REV.
A

(R) BOLT, TEE HEAD - CHAMFERED, PD SHANK
NICKEL ALLOY (UNS N07001), 165 KSI MIN UTS
.3125-24 UNJF-3A

SAE AS3234
SHEET 1 OF 3

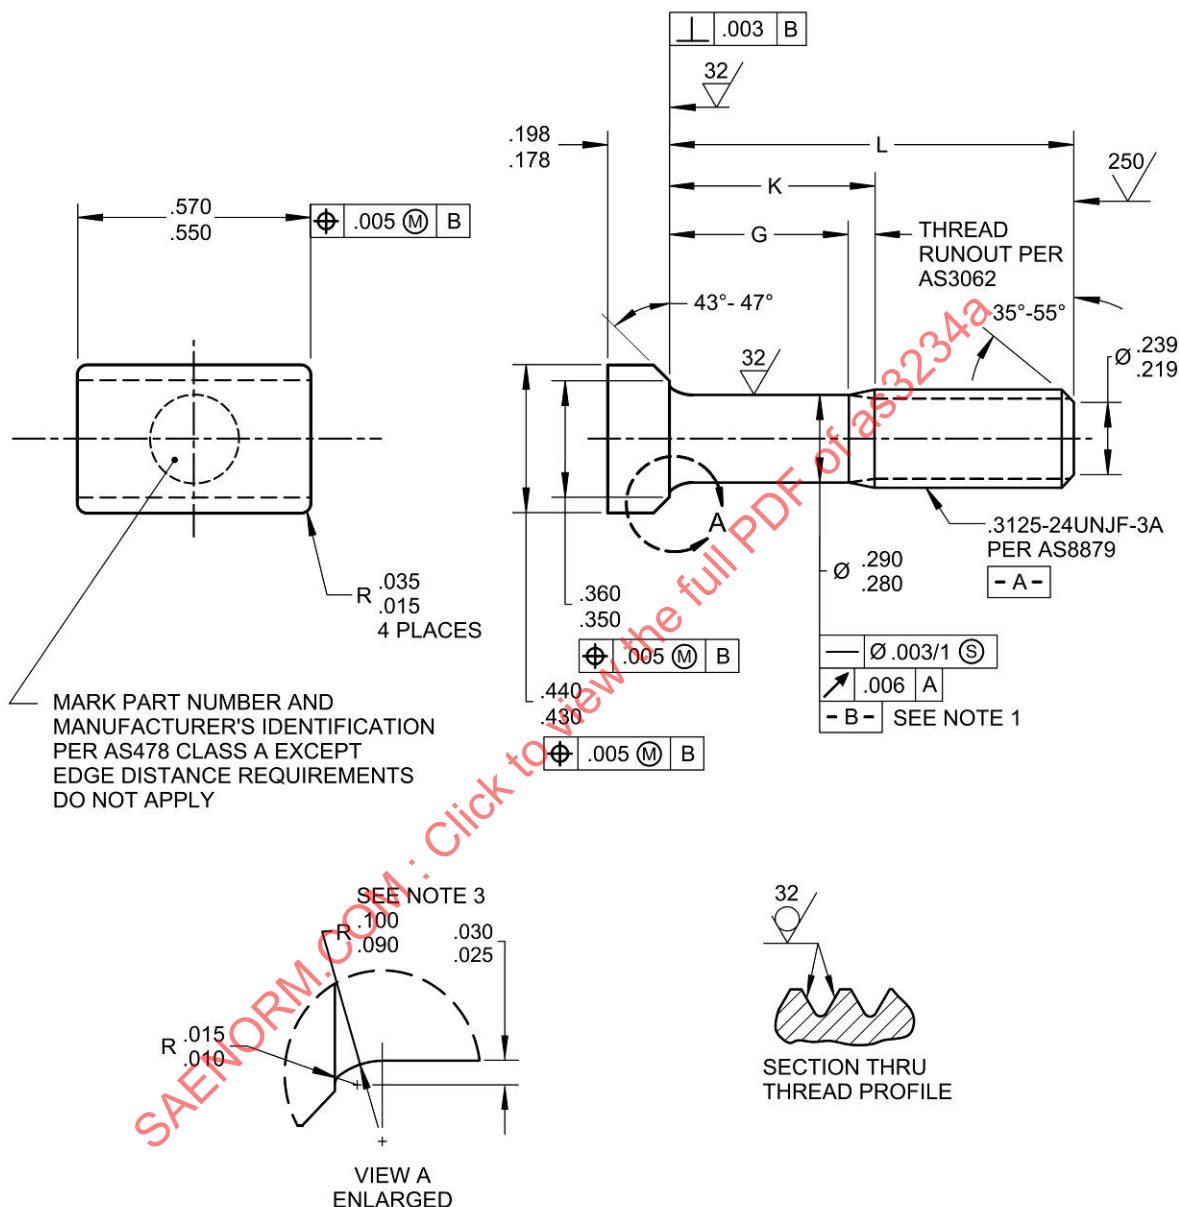
ADD NEW PART NUMBERS AS3234-04 THRU -13, UPDATE THREAD SPECIFICATION TO AS8879, ADD EXCEPTION TO EDGE DISTANCE REQUIREMENTS FOR HEAD MARKING, UPDATE DIMENSIONING AND TOLERANCING TO ANSI Y14.5M-1982, UPDATE THREAD RUNOUT TO AS3062, REMOVE METRIC DIMENSIONS AND REFERENCES, REFORMAT TABLE 1, UPDATE SURFACE TEXTURE NOTE, DELETE FPI NOTE (DUPLICATES AS7471 REQUIREMENT), AND REDRAW FIGURE 1, GENERAL REVISION AND EDITORIAL UPDATE.
